SUBJECT: Forwards response to request for addl info in support of review of proposed Tech Specs for upgraded ECCW sys.

Subject: Oconee Nuclear Station
Docket Nos. 50-269, -270, -287
Proposed Revision to Technical Specifications
for the Upgraded ECCW System
Technical Specification Change # 96-09
Supplemental Information Letter #5

Figure 1 Typical Hoffman FS Cabinet

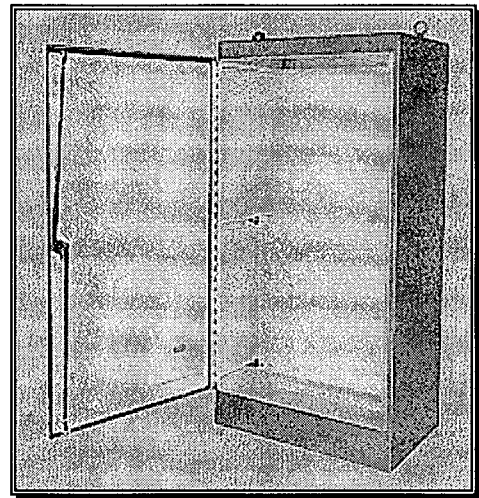
1. Physical dimensions of each new cabinet, single-bay or multi-bay,
2. Cabinet Amplification factors used for each cabinet,

Cabinets 1ESV1 and 2ESV1 are 60" tall x 36" wide x 24" deep. They are single bay cabinets with a single door similar to the cabinet shown in Figure 1. An amplification factor of 4.5 (GIP, Rev 2, Corrected 6/28/91, Table 6-2) was used for these cabinets. The cabinets are mounted in the Auxiliary Building, therefore, the floor spectra is also multiplied by 1.5 for median centered in-structure spectra (GIP Table 6-1). This results in a total in-cabinet amplification factor of $4.5 \times 1.5 = 6.75$.
